**Livingston County Water and Sewer Authority
Request for Proposals
For Professional Engineering Services
For the
Livingston County Water and Sewer Authority (LCWSA) Regional Water Supply Project
November 13, 2025**

Questions regarding the RFP for Professional Engineering Services:

**HEMLOCK PUMP STATION:
DEMO PLAN AND PROPOSED FLOOR PLAN**

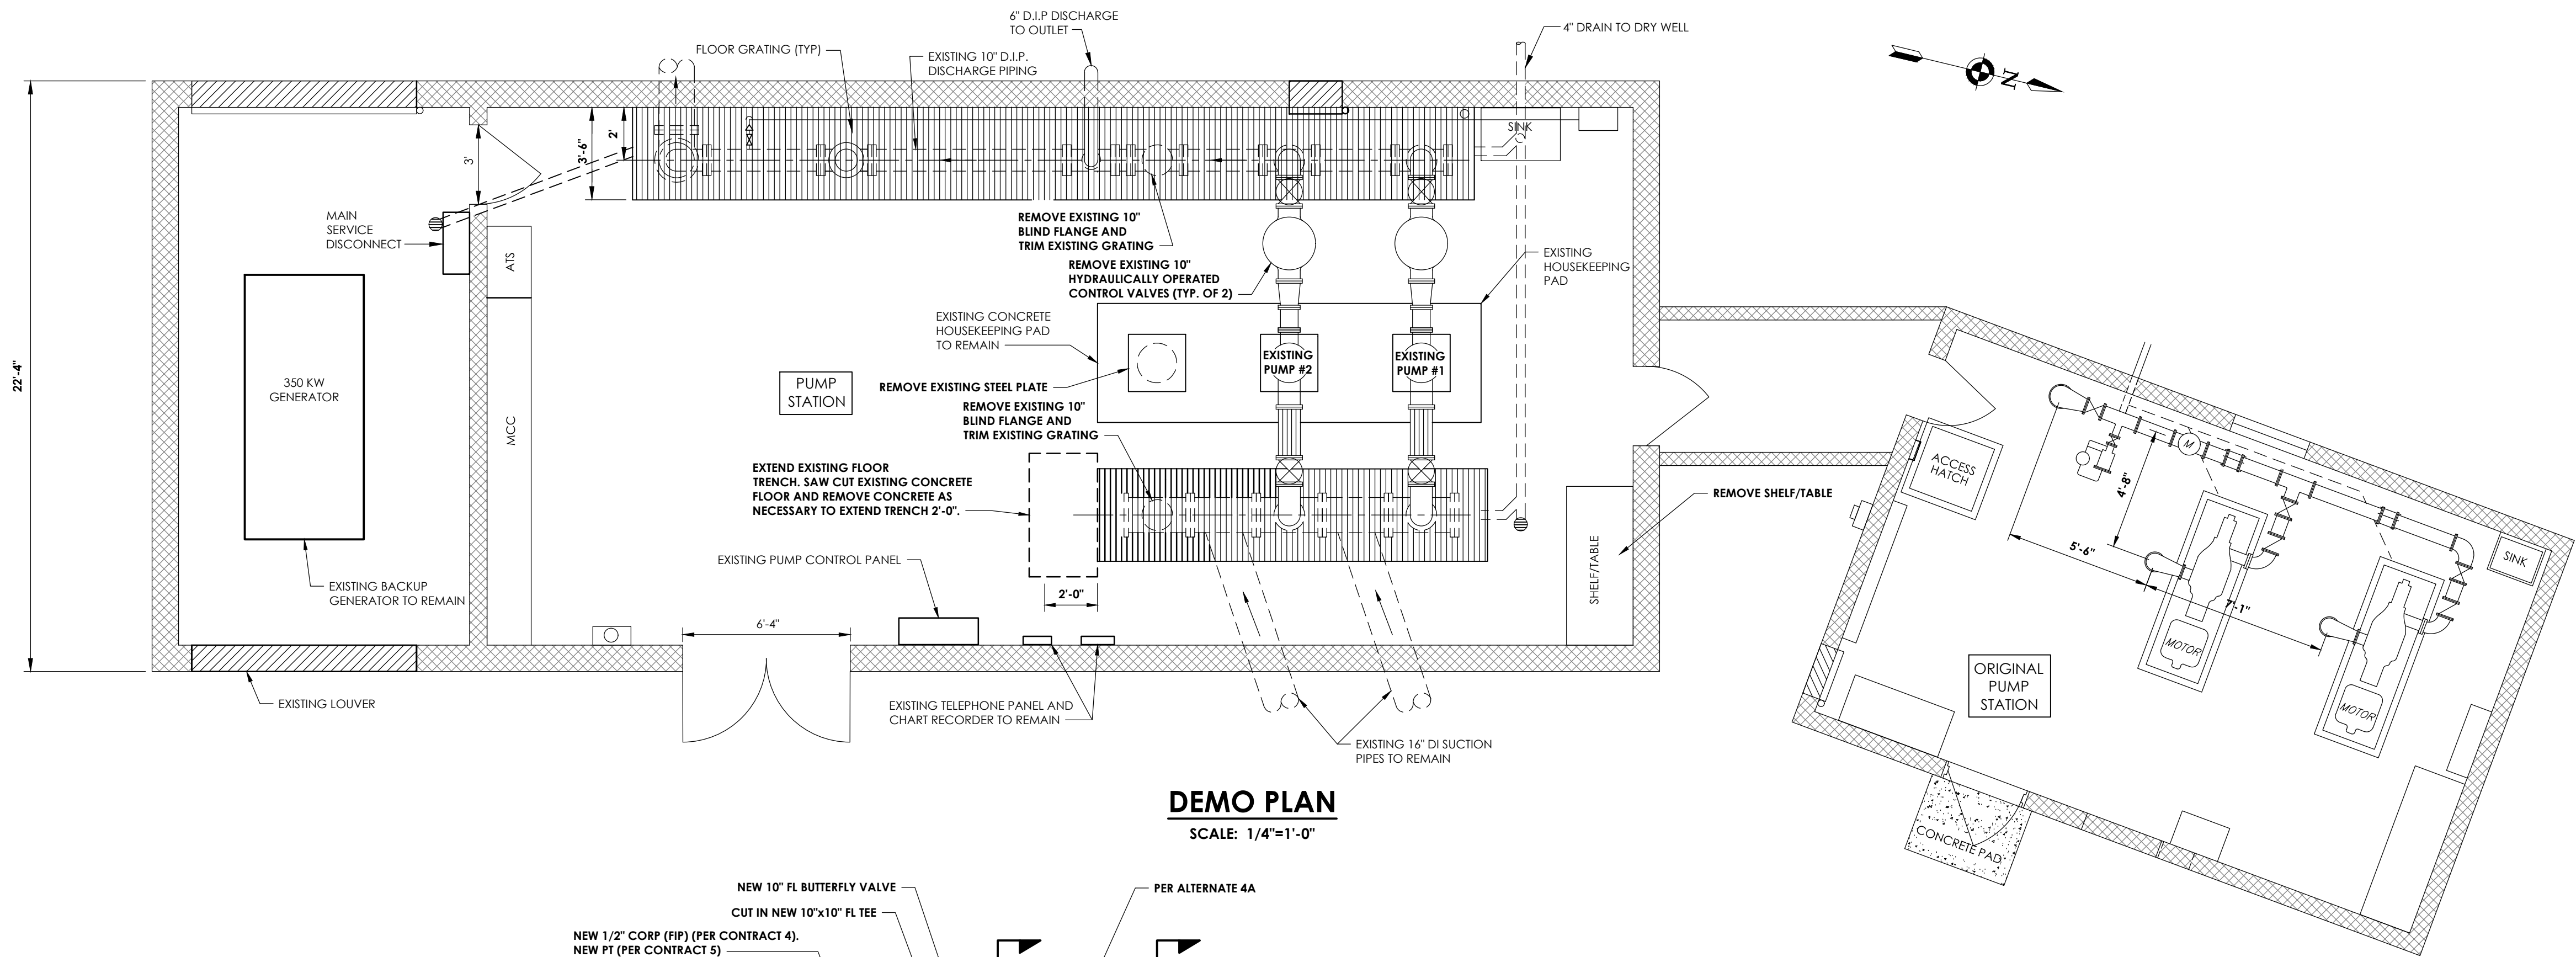
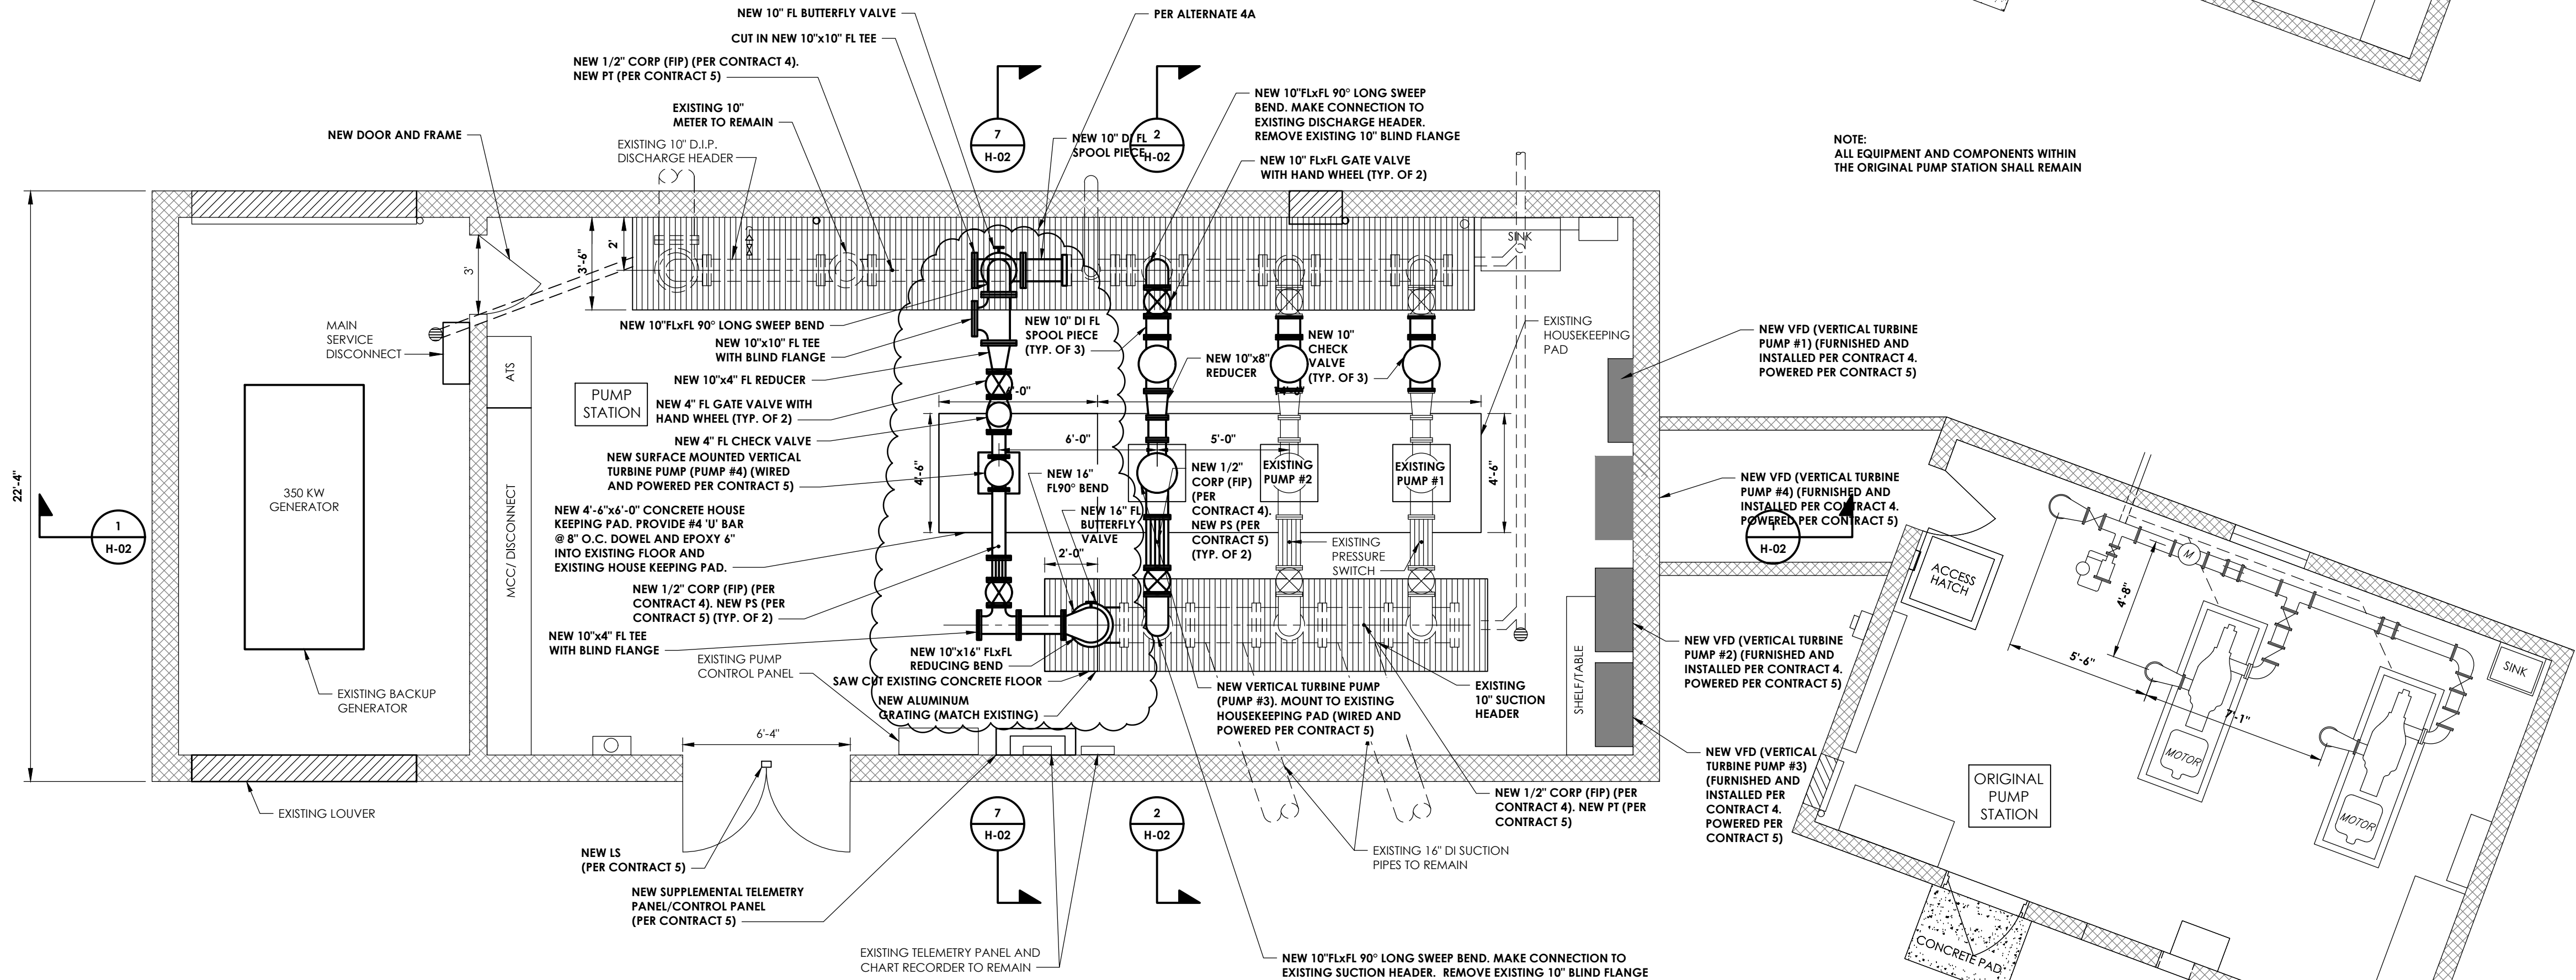
6. Are record drawings available for the Hemlock Pump station and if so, are they available in AutoCAD format? Can these be provided during the proposal phase? If record drawings are not available, please let us know if a site visit can be made prior to the submission of the proposal.

Response: Attached please find the as-built drawings for the Hemlock Pump Station (2017).

Proposed Livingston County
Murray Hill Campus
Transmission Main

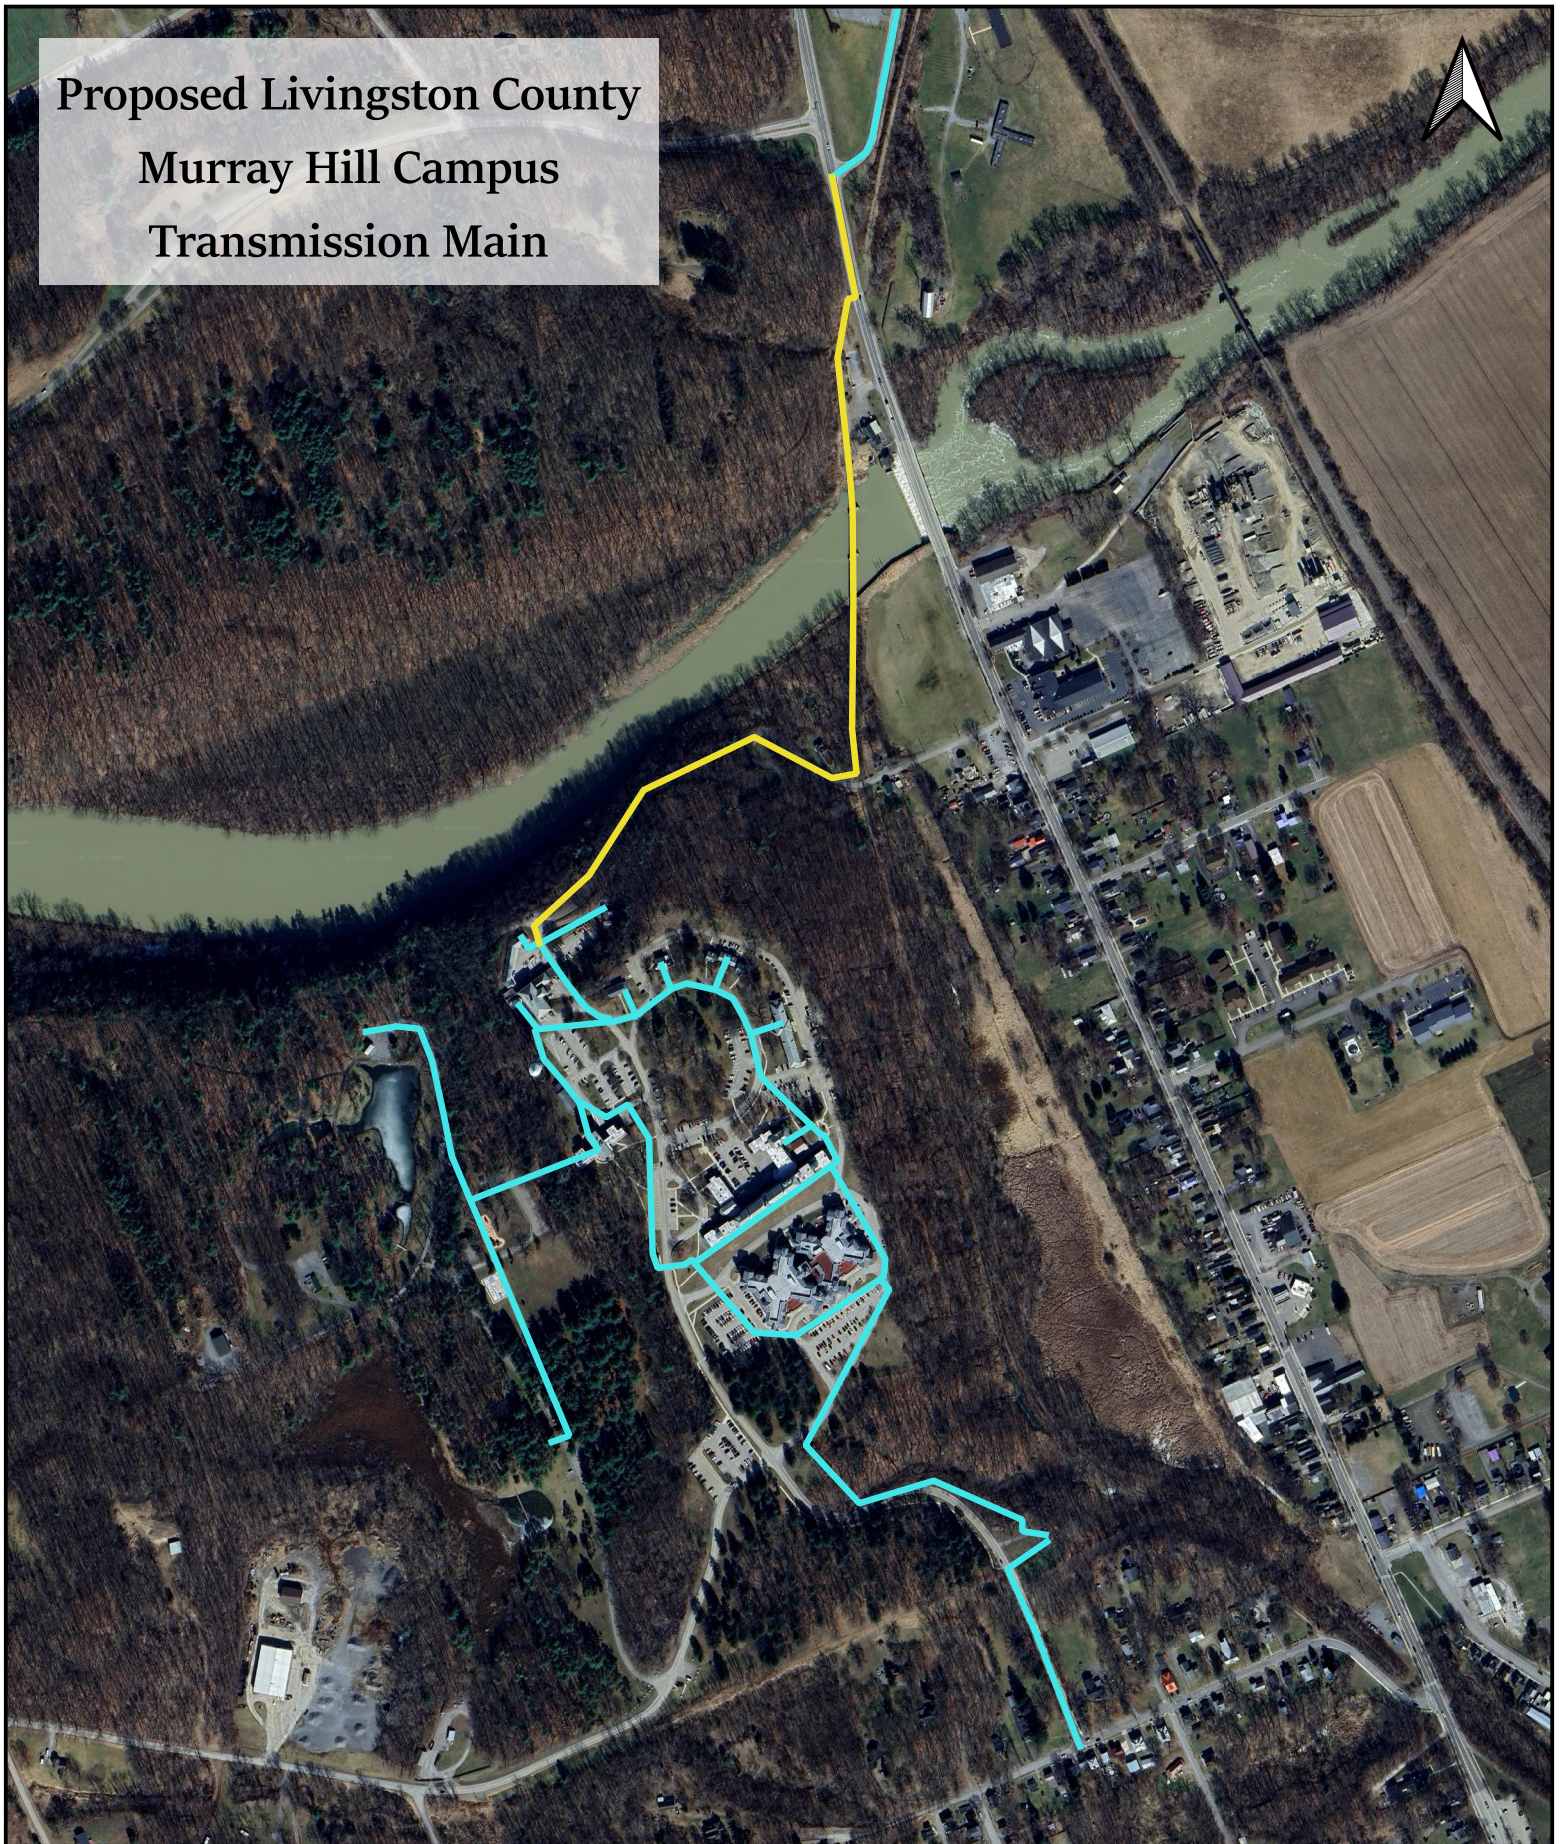
9. It is unclear if the Amendment No. 2 map shows the full limits on the Murray Hill Campus that will be required to connect to the existing campus water mains. Can it be verified that the map does show the final connection, or if not, can that be provided?

Response: Attached please find an estimated distribution route for the Livingston County Murray Hill Campus transmission main. This route alignment is subject to final design and approval.
